SUSITNA HYDROELECTRIC PROJECT

**ACRES INTERNAL REVIEW BOARD
MEETING # 4**

**REPORT
SEPTEMBER 8, 1981**

MINUTES OF MEETING
held at the offices of
Acres Consulting Services,
Niagara Falls, Canada on
September 8, 1981

DEVIL CANYON LAYOUT STUDIES (R. Ibbotson)

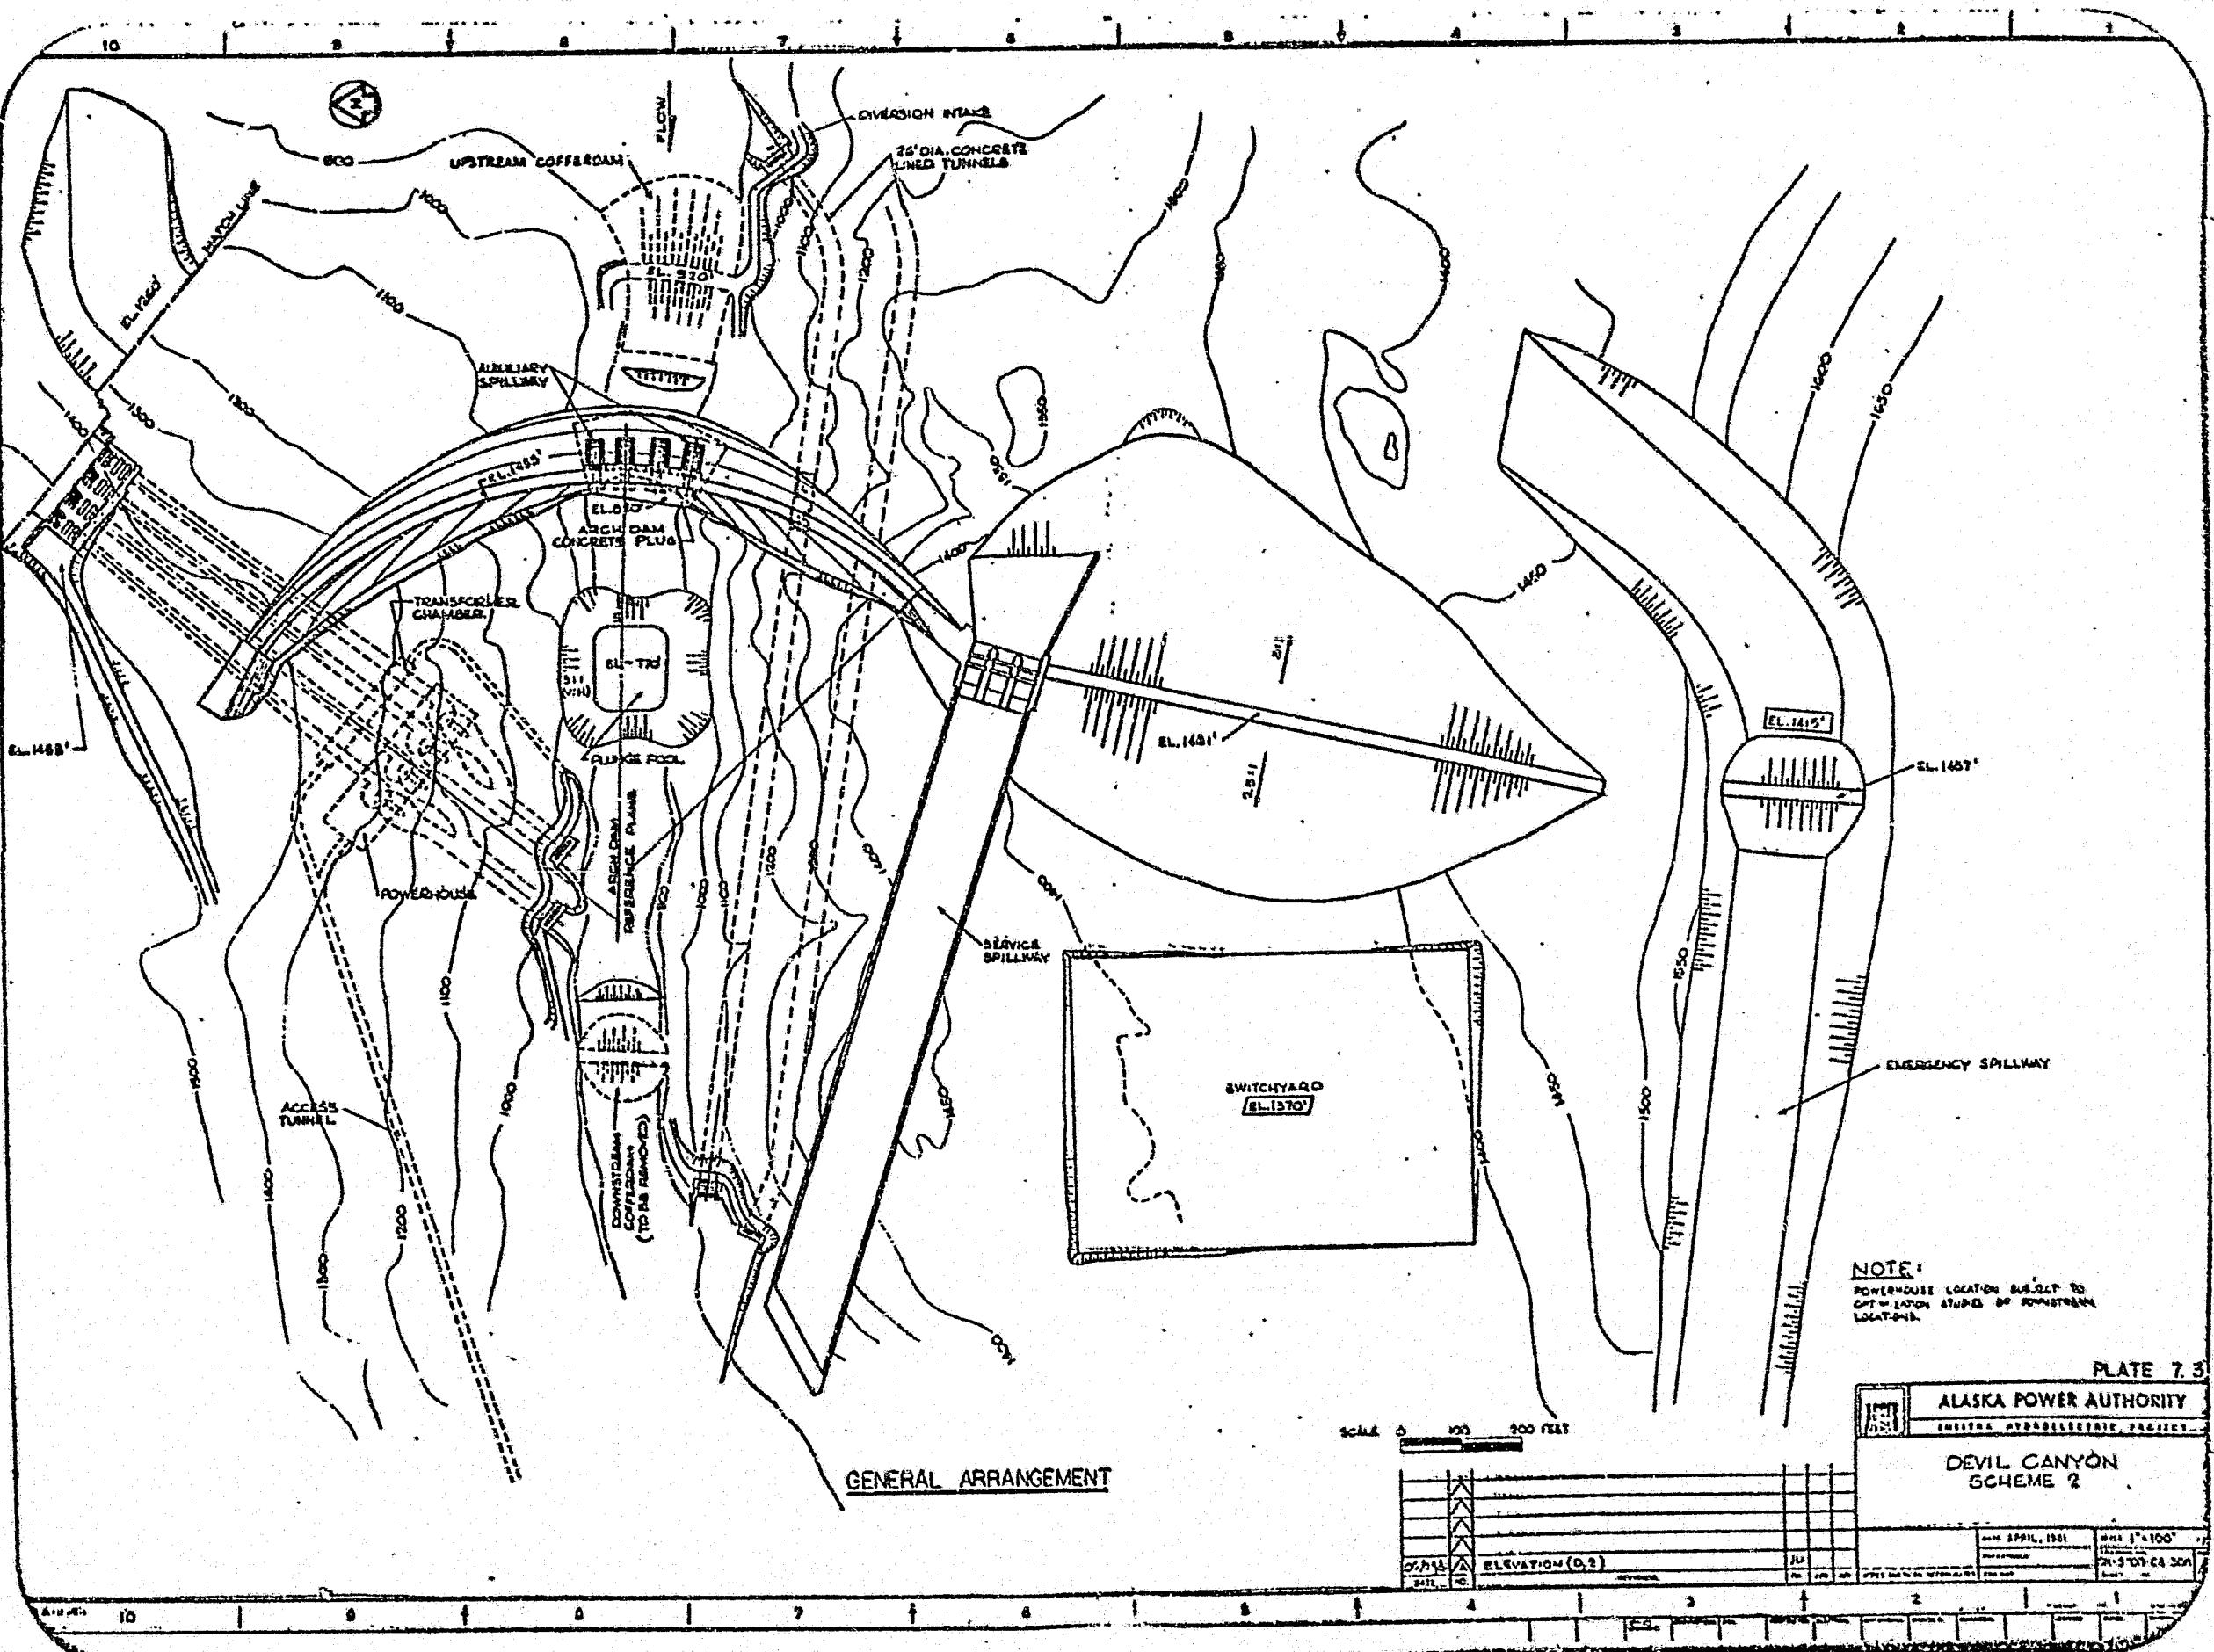
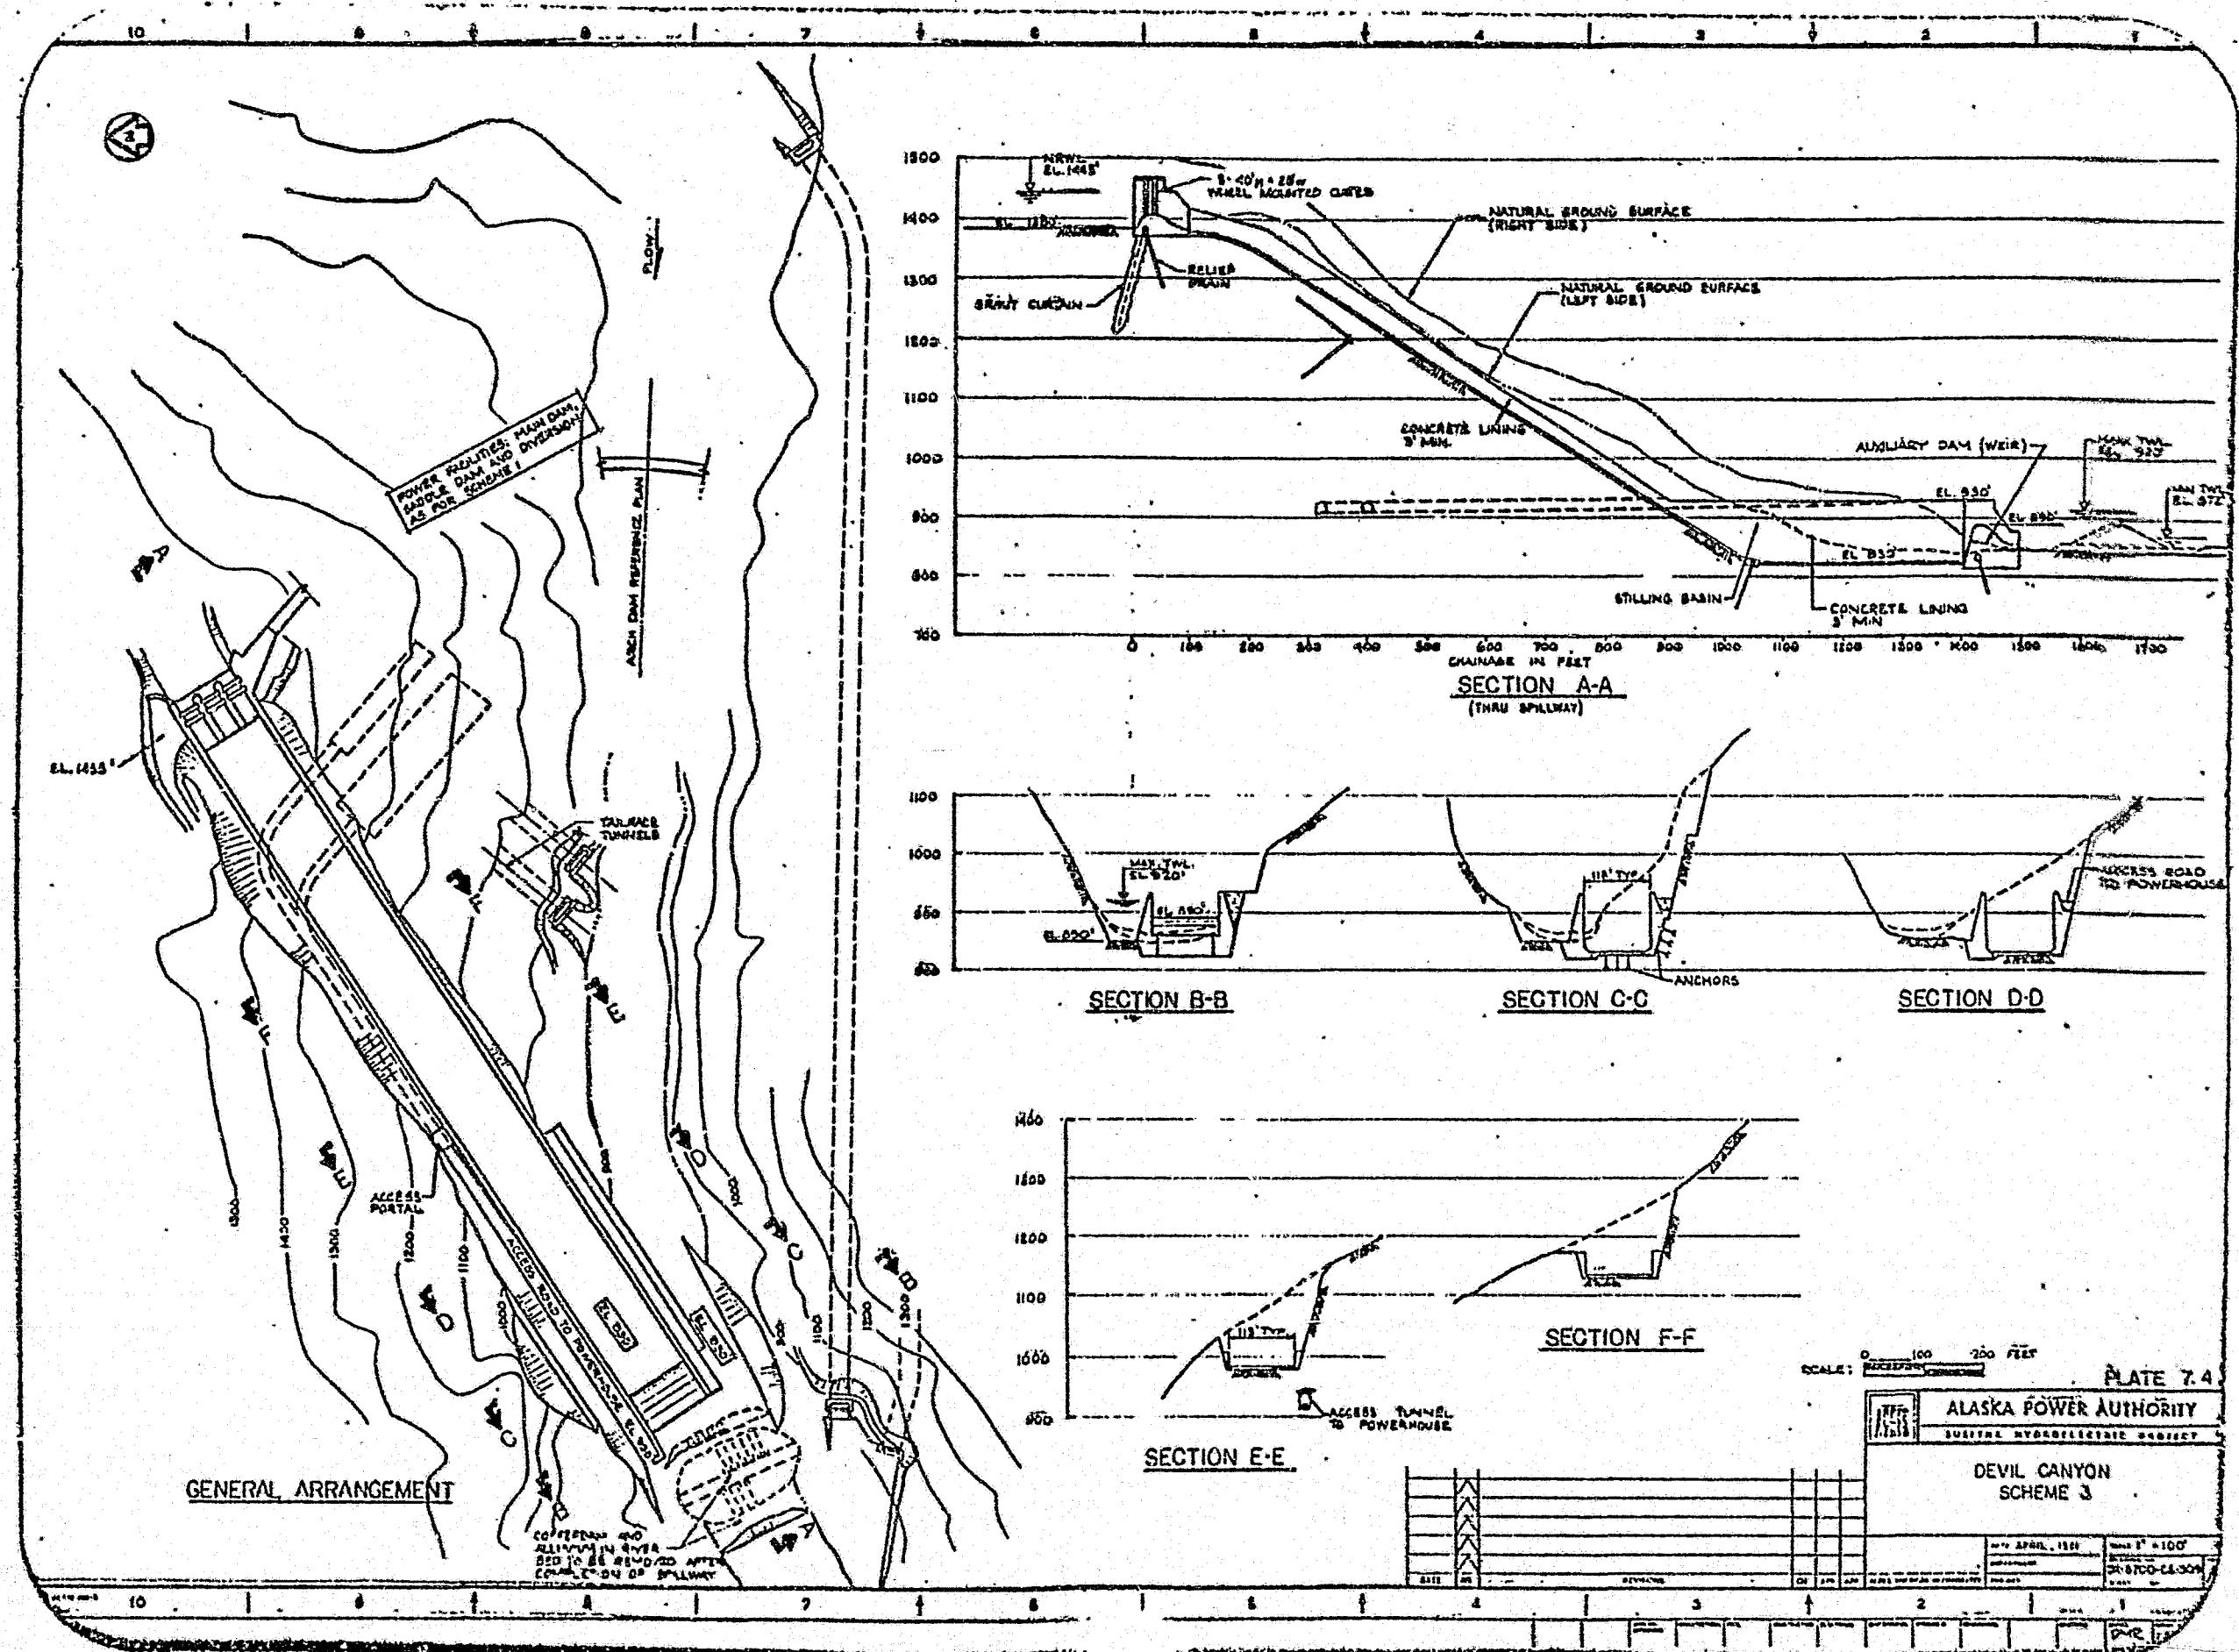
- Stilling basin walls are too thin if unsupported by rock.

- Need for precedent/experience report on HB valves particularly with regard to vibration and winter operation. Model studies will be required in design stage.
- Recommended at least 10D straight section before the valve to establish linear flow pattern, (particularly at Watana).
- To avoid supercooling the trashracks on the intake should not be exposed above W.L.
- Switchyard position is on opposite bank to powerhouse.
- Tailrace shown is freeflow; one extra set of gates?

The structural adequacy of the stilling basin at Devil Canyon was questioned. The fuse plug in the emergency spillway should, if possible, be replaced by a positive control.
